STAFF REPORT

DATE: March 2, 2022 updated March 7, 2022

RE: 5537 College Road-KOTS (Landscape Sec 108 Review)

FROM: Karen DeMaria, City of Key West Urban Forestry Manager

SHEET NUMBER:
L-1

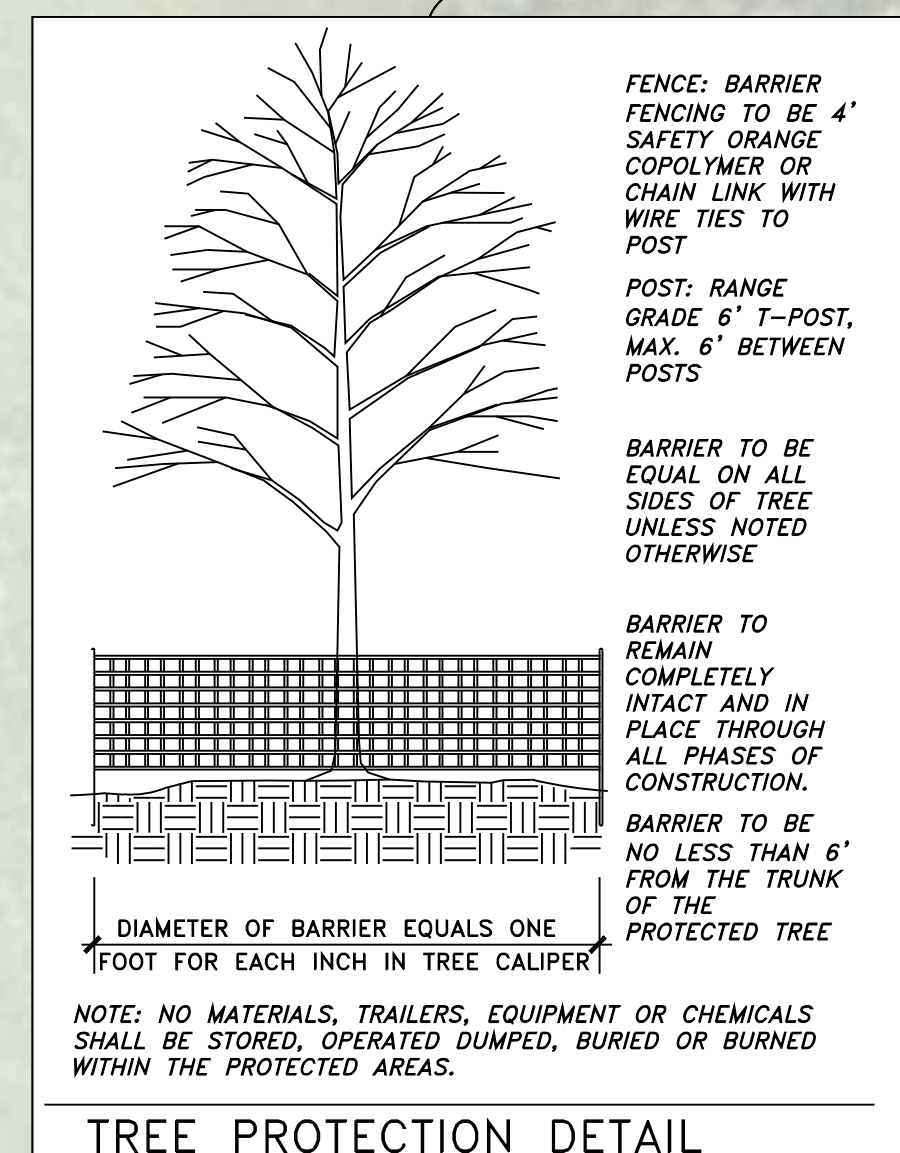
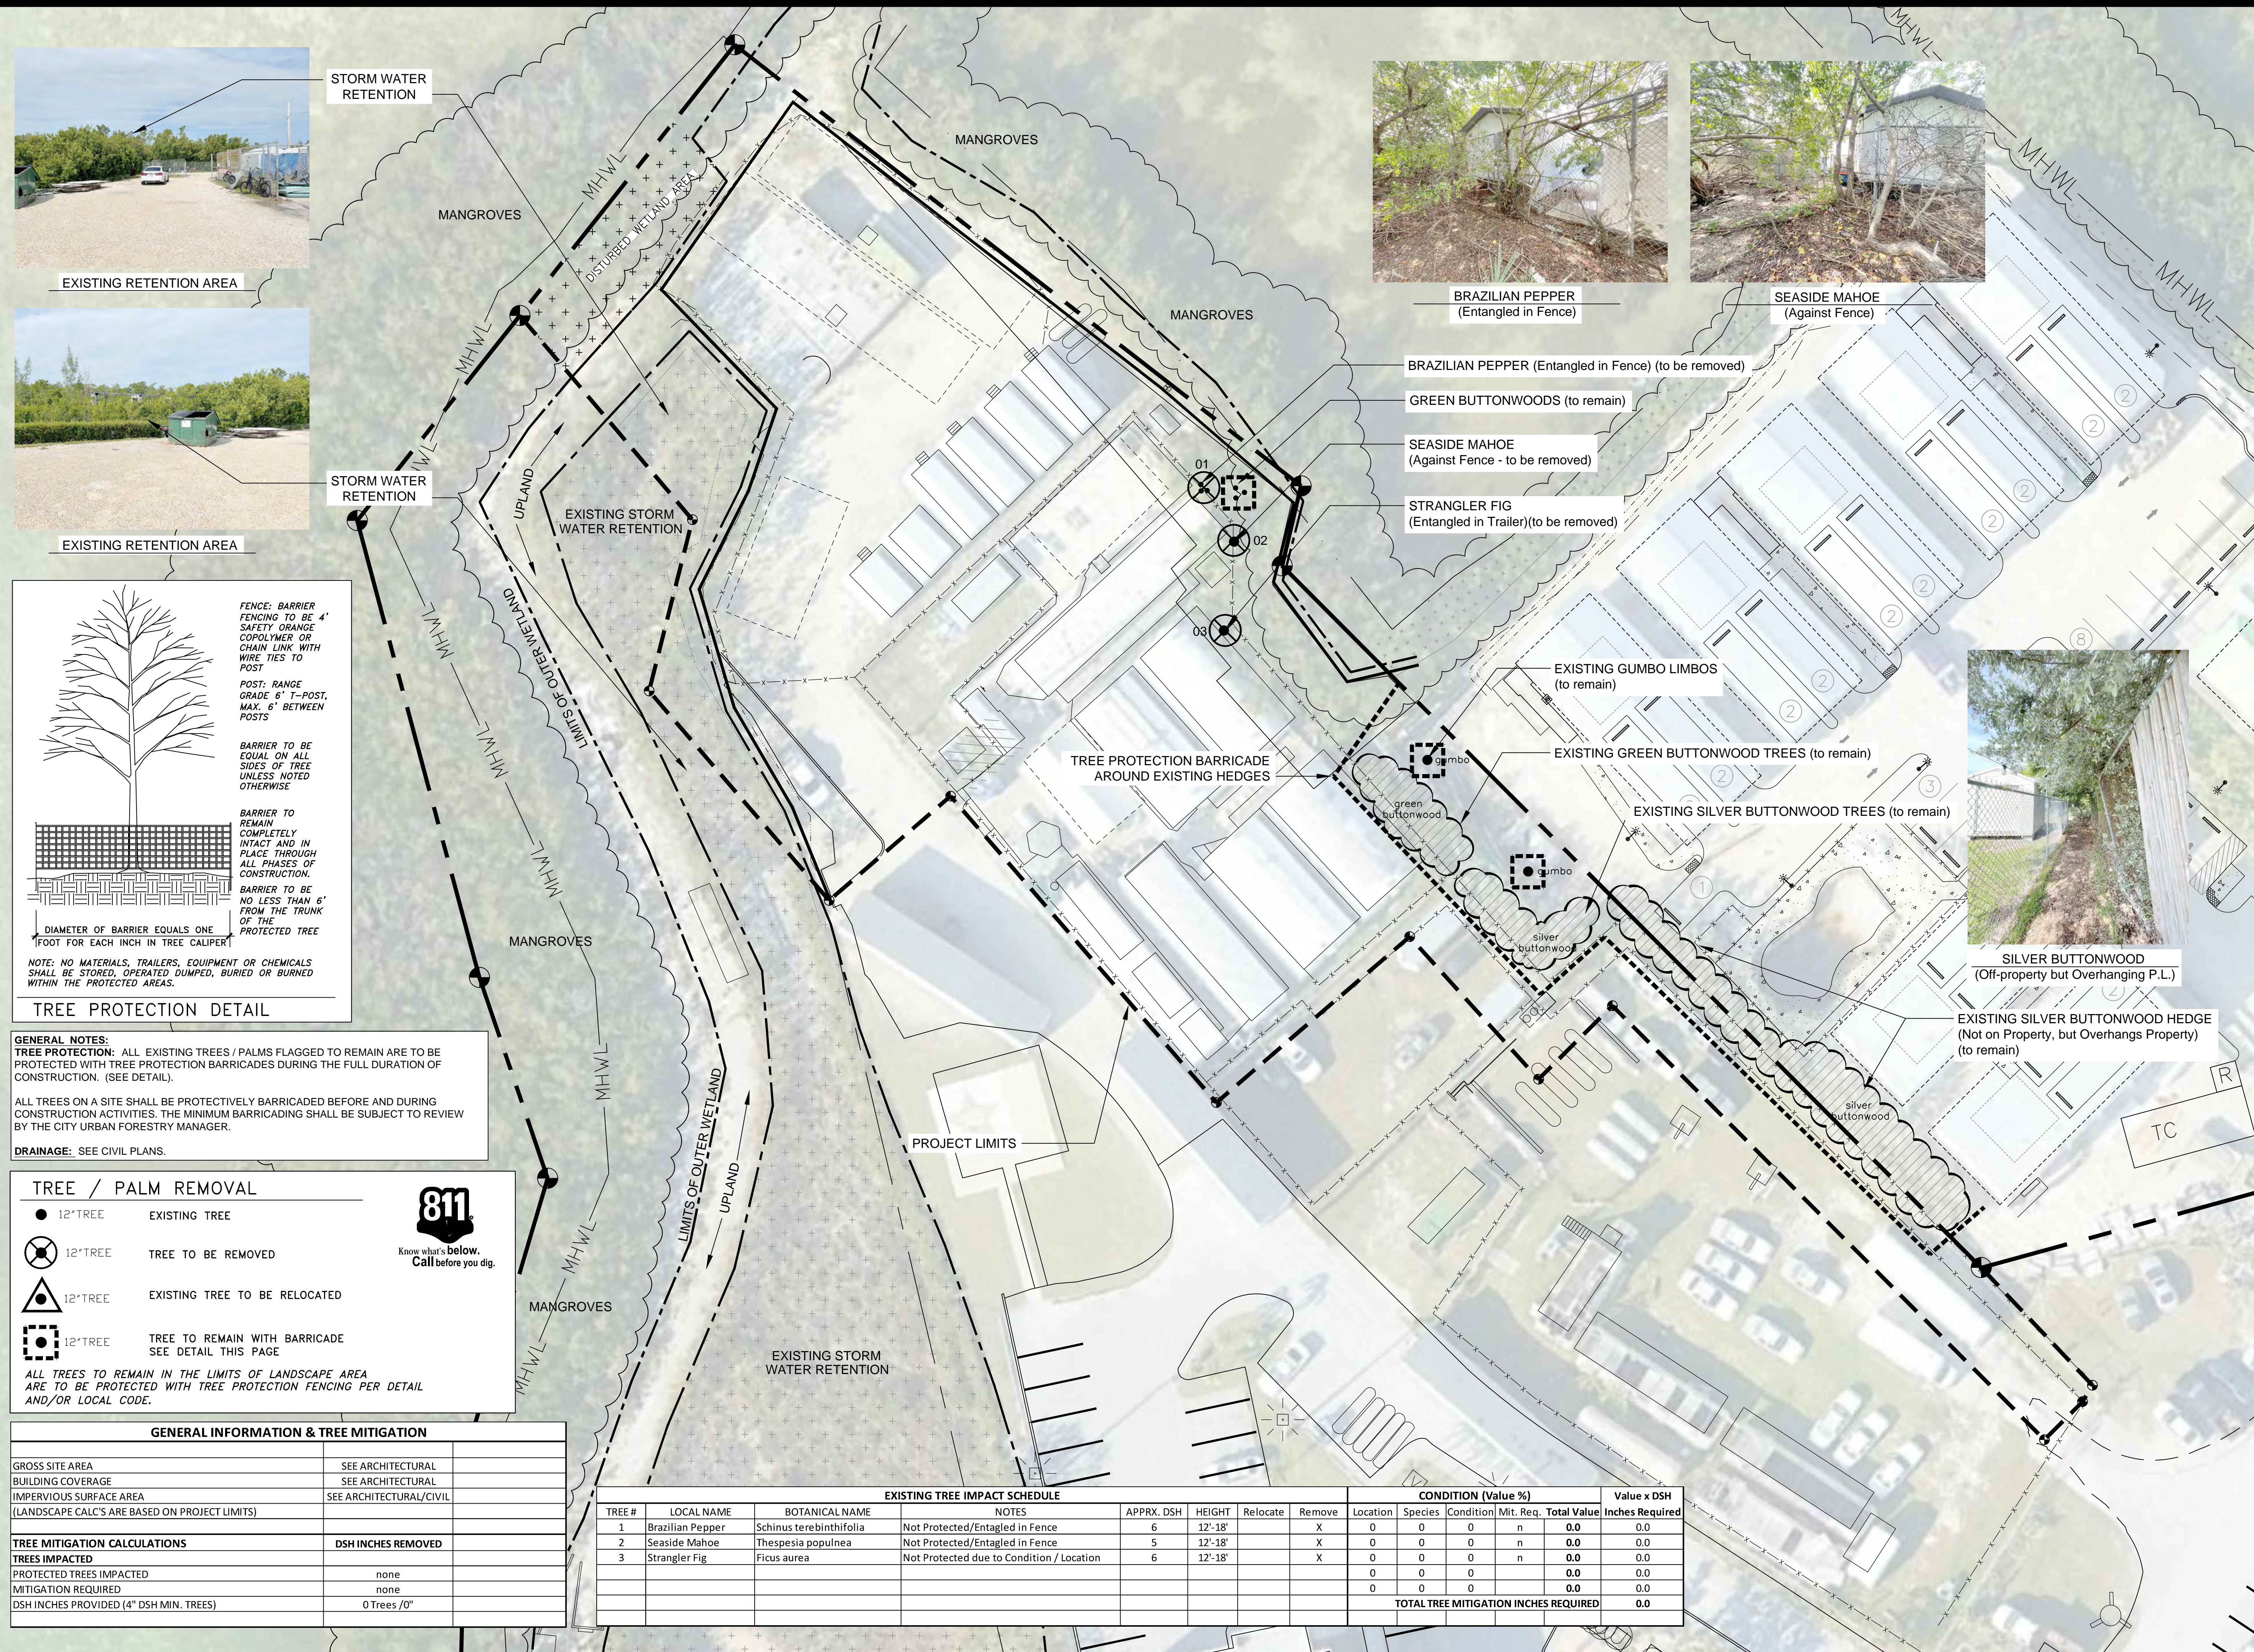
2. Sec 108-289: The project will require the removal of (1) Strangler Fig tree currently growing against a structure. Numerous Buttonwood trees on the eastern side of the property including along the existing walkway, shall remain as well as two Gumbo limbo trees. The request to remove the Strangler Fig tree was approved by the Tree Commission on February 7, 2022 and requires the planting of a total of 3 caliper inches of approved trees, FL #1, from the approved list, to be planted on site and incorporated into the landscape plan.

SHEET NUMBER:
L-2

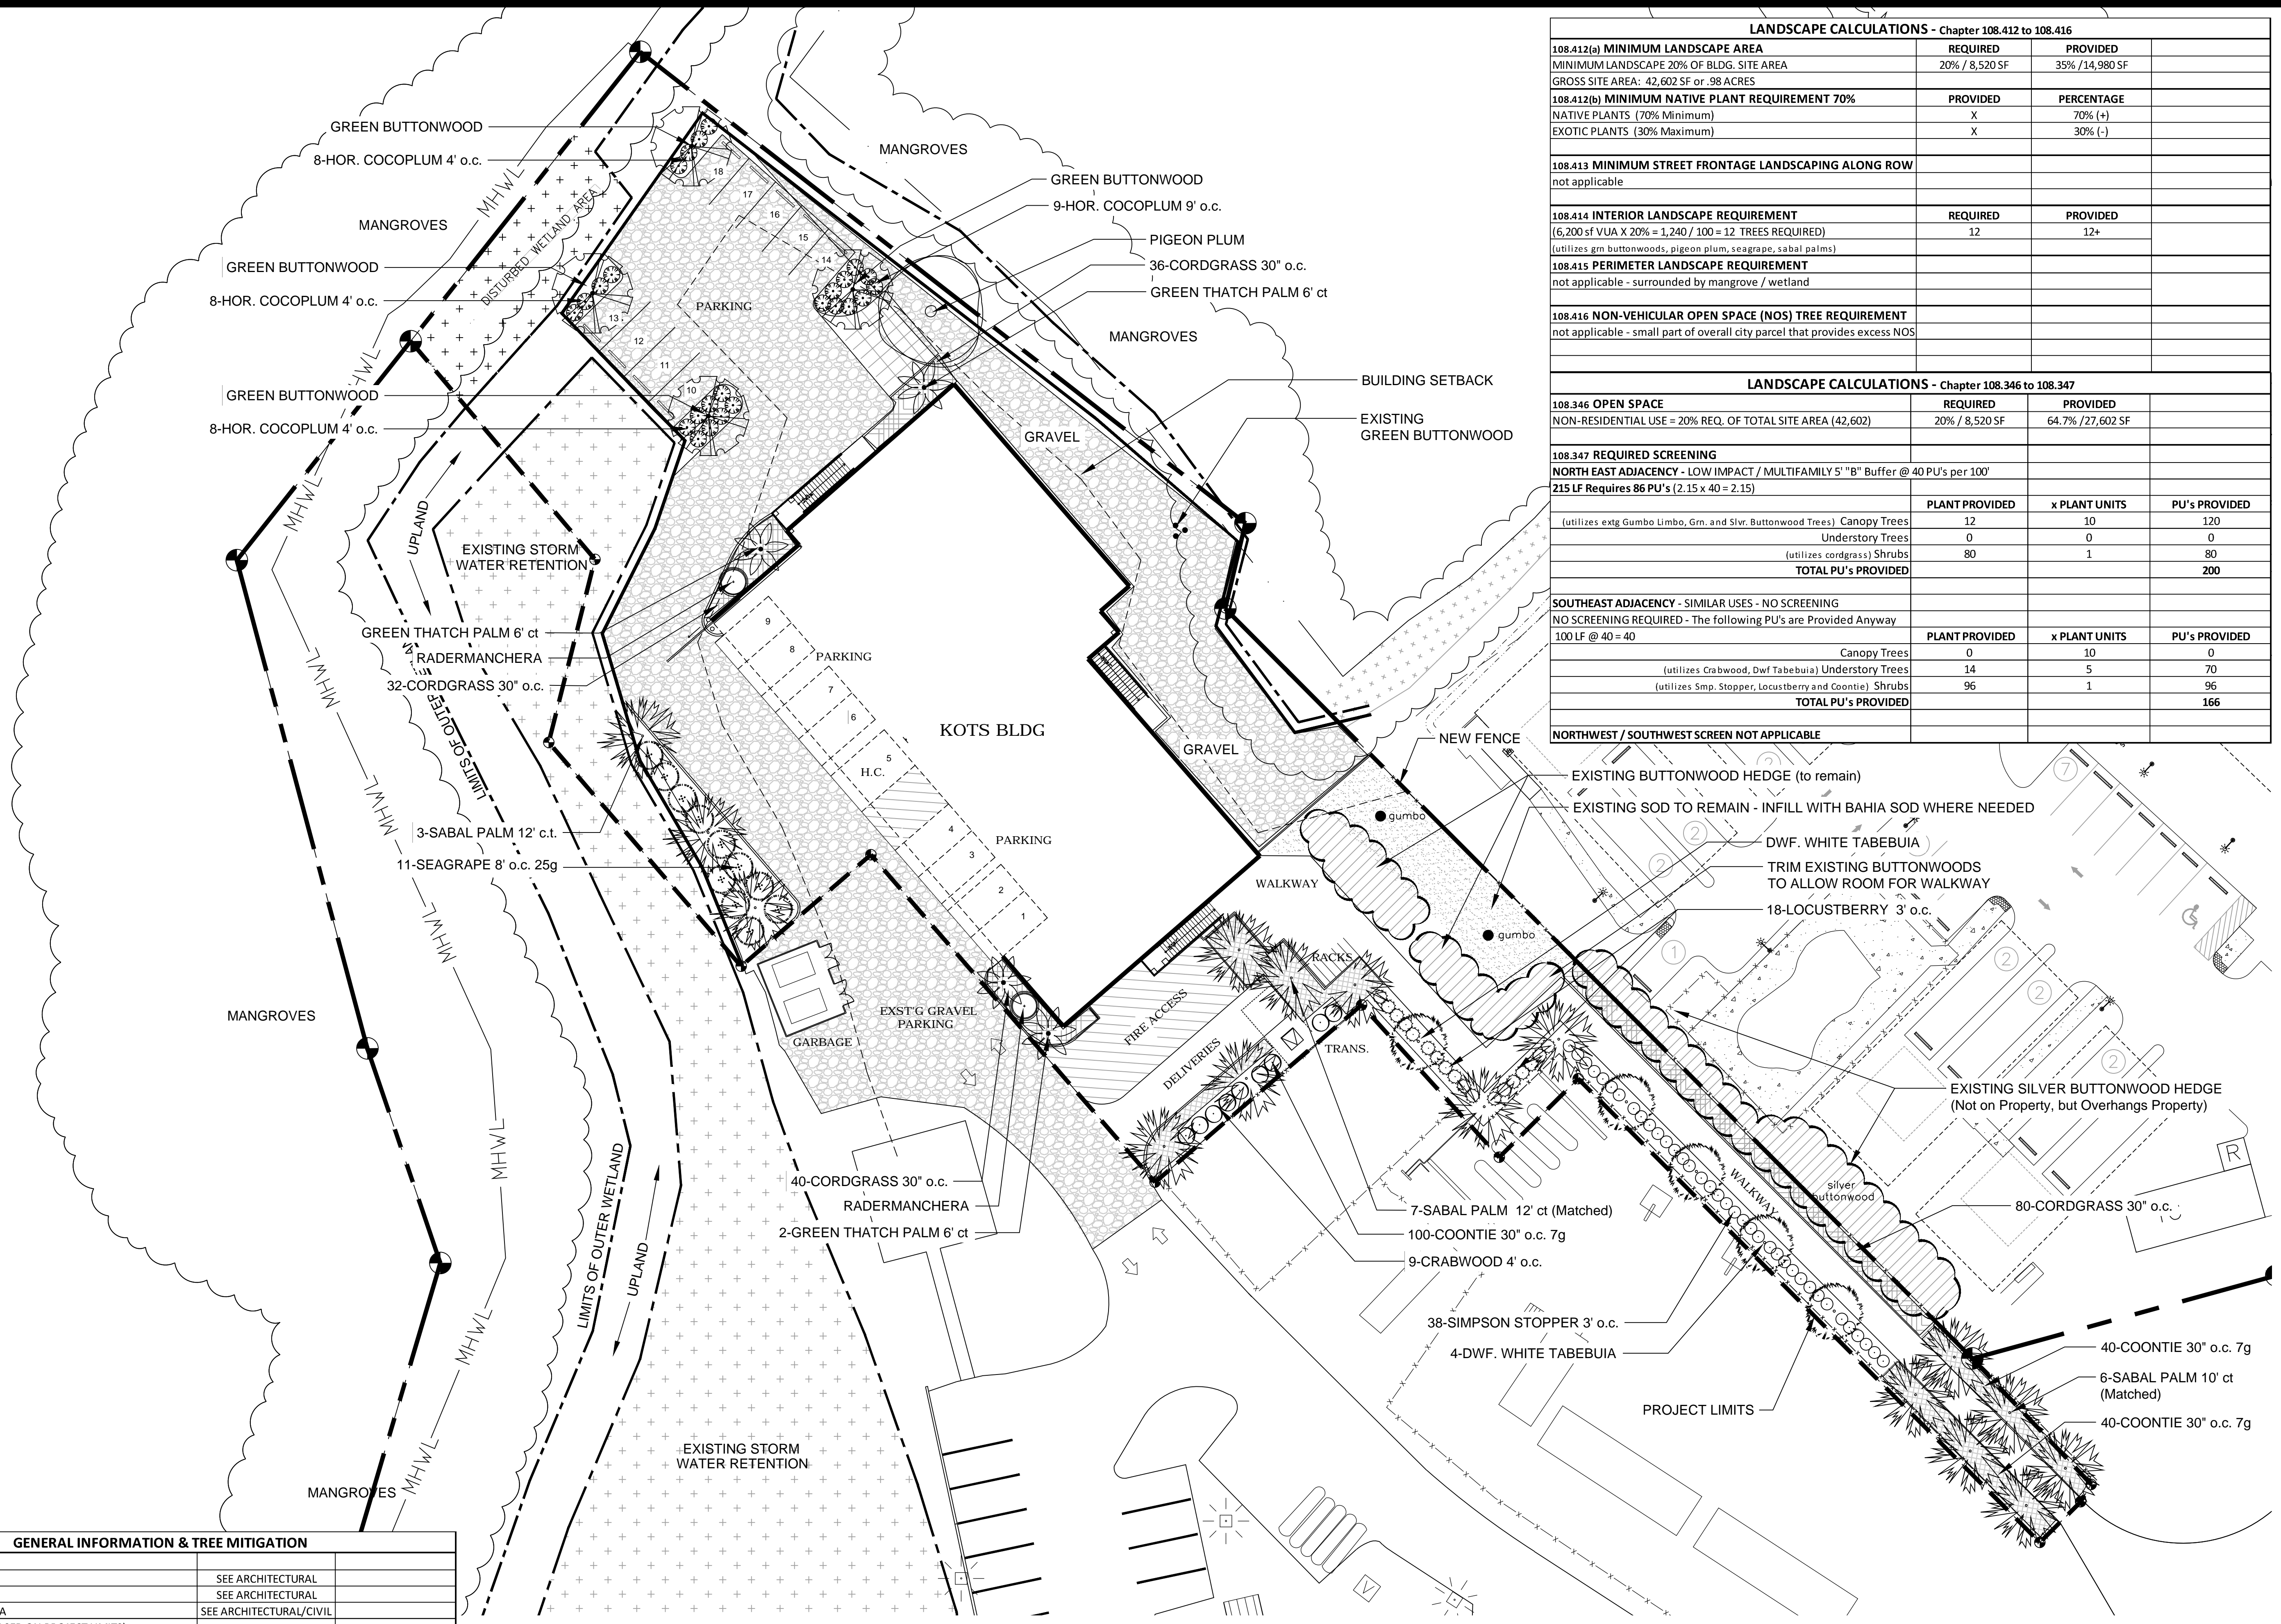
3. Sec 108-346: According to the landscape plan, the project is proposing 64.7% open space. According to the architect plans, the project proposes 55.4% open space. There are some Brazilian pepper and Seaside Mahoe trees, both invasive exotic plant species, on the site that will be removed. Due to the seed source being in the soil, the property maintenance plan must include a statement regarding maintenance of the property to remove any invasive exotic plant species.

A. The walkway/access area on the southeastern portion of the lease area would require an E buffer (medium impact-multi family) and this section of code does not have specific buffer requirements for screening (specific requirements to be determined by the City) therefore, a review is being based on the low impact requirement, B buffer of 40 plant units per 100 linear feet of landscaped area that is 5-9 ft wide.

The plan proposes a 6 ft wide landscaped planter along the walkway access area with the neighboring property that currently contains existing, tall buttonwood hedged trees. Three Sabal Palms, 80-Cordgrass shrubs, and Coontie plants will be planted (+95 new plant units) to create a vegetative buffer along an approximate 200 ft long area.

An additional approximately 50 ft long area along this walkway turns approximately 20 feet away from the property line and contains additional, existing buttonwood trees along an existing wire fence. No new vegetation is proposed to be planted on this section of property/lease line area. An opaque fence will be installed the lease line.

B. The western side of the walkway/access area on the southwest side of the lease area abuts existing government use areas currently used as a vehicle storage area with above ground storage tanks (medium-low impact). A B buffer area is required (40 plant units per 100 linear feet). The planting bed is 6 ft wide and is approximately 316 linear feet therefore, 124 plants units are required for this area. The landscape plan proposes the planting of 5-White Tabebuia and 9-Crabwood subcanopy trees, 8-Sabal Palms, 38-Simpson Stopper and 18-Locustberry shrubs and Coontie plants (+168 plant units).

C. The project does not propose continual buffer landscaping along the northeast, north, northwest, and western lease boundary lines. A large fringing mangrove and wetland area currently exists along most of this area therefore, a vegetative buffer currently exists and new vegetation is not needed (Sec 108-352). A structural buffer/wall-fence will be built upland of the jurisdictional wetland line. On the north and west side, an access drive and parking area will be created. Two small landscape planter areas will be created along the lease/property line and access driveway.

9. Sec 108-414 Interior parking areas: There are two interior parking areas on the parcel. One parking area is located under the pile supported main structure and the second parking area is located in the northern area of the property. The landscape does include 4 planters with a shade tree and shrubs in each planter in the northern parking area containing a total of 9 parking spots. The dimensions of these planters are not known at this time.

13. Sec 108-450: Landscape screening has been provided where necessary.
14. Sec 108-481: The landscape includes the planting of 33 new trees and 20 new palms. The property contains numerous existing buttonwood trees. The proposed landscape plan meets this code section requirement.
